TO: Mercedes-Benz Dealer Principals, General Managers, Sales Managers, Service Managers, Parts Managers	FROM: Gregory Gunther, Department Manager, Vehicle Compliance and Analysis, Engineering Services
RE: Recall Campaign Launch Notification - Update Vehicle Body Sealing – water intrusion - Supplemental MY20 247 (GLB-Class)	Date: July 9, 2021

Campaign No. :	NHTSA ID	Campaign Desc. :	Vehicle Body Sealing- water intrusion Supplemental
2020070009	21V403 20V246	20P6290301

SUBJECT: **Model GLB-Class vehicles (247 platform)**
Model Year 2020

Vehicle Body Sealing- water intrusion

Figure 1

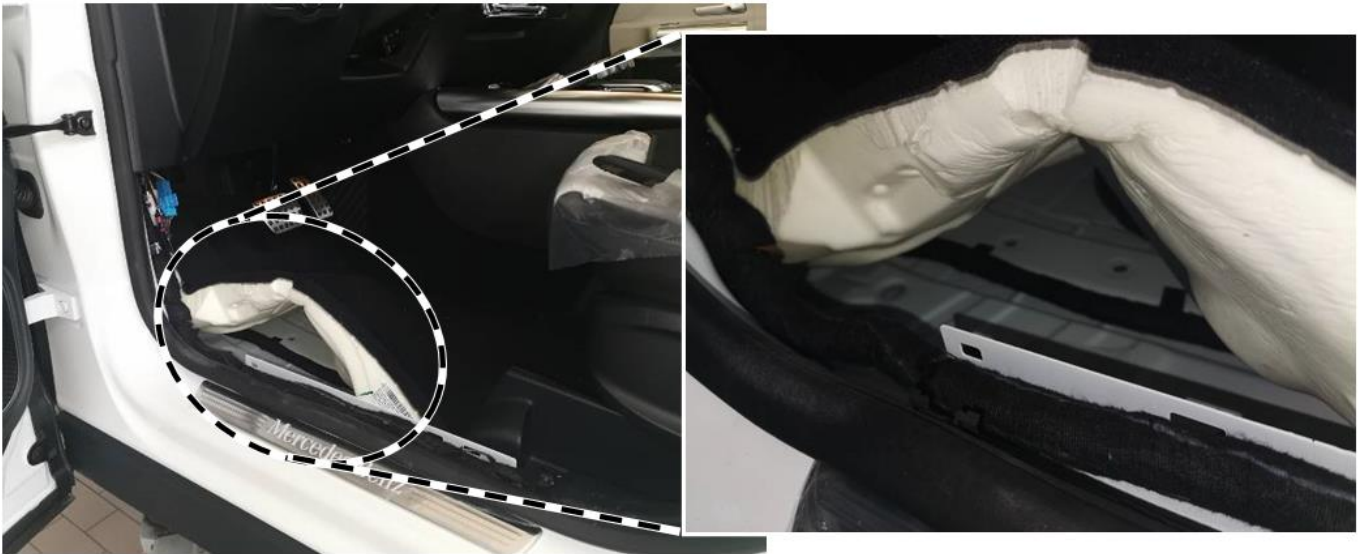
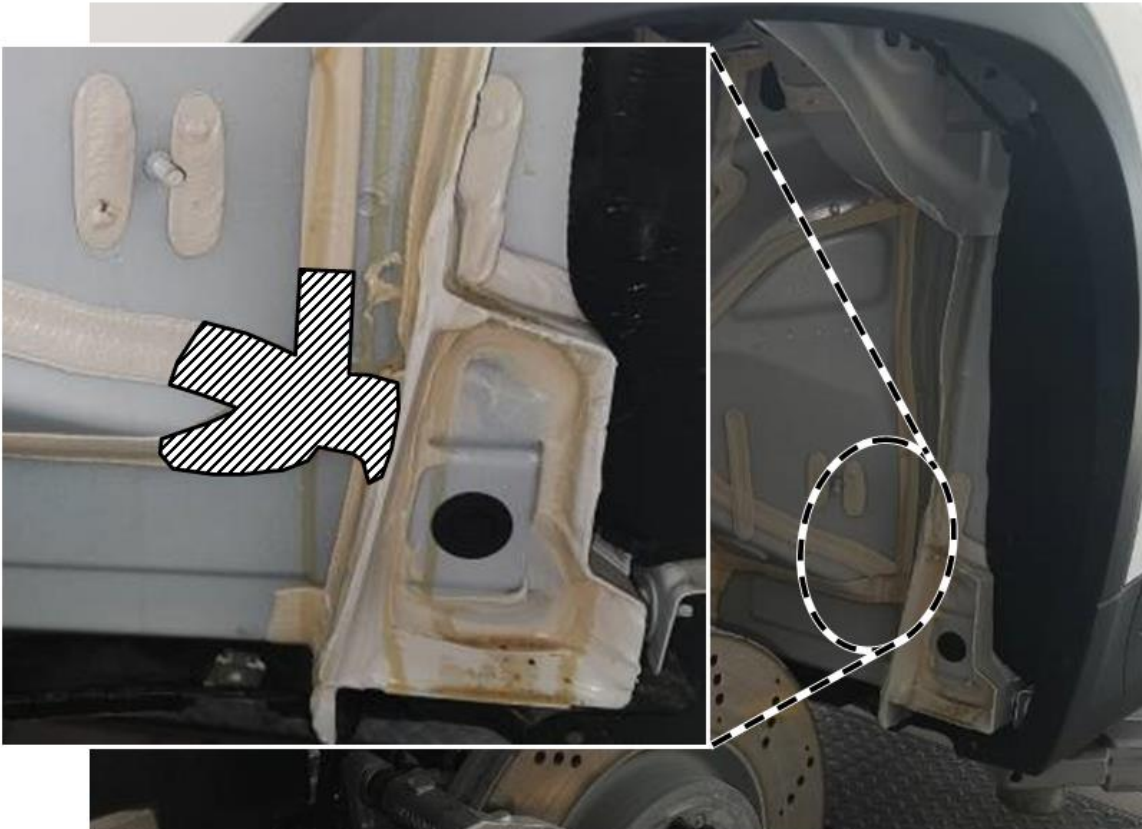
1. Remove right and left front door sills (**AR68.30-P-4101MFA**).
2. Lift floor covering in footwell on front driver's side and front passenger side and check for moisture (**Figure 1**).
i There may be no ingress of water under the floor covering in the footwell on the front driver's side and/or front passenger side.

- a. **No** ingress of water in footwell on front driver's side and/or front passenger side: **End measure.**
- b. Ingress of water in footwell on front driver's side and/or front passenger side:
Carry out **work procedure.**
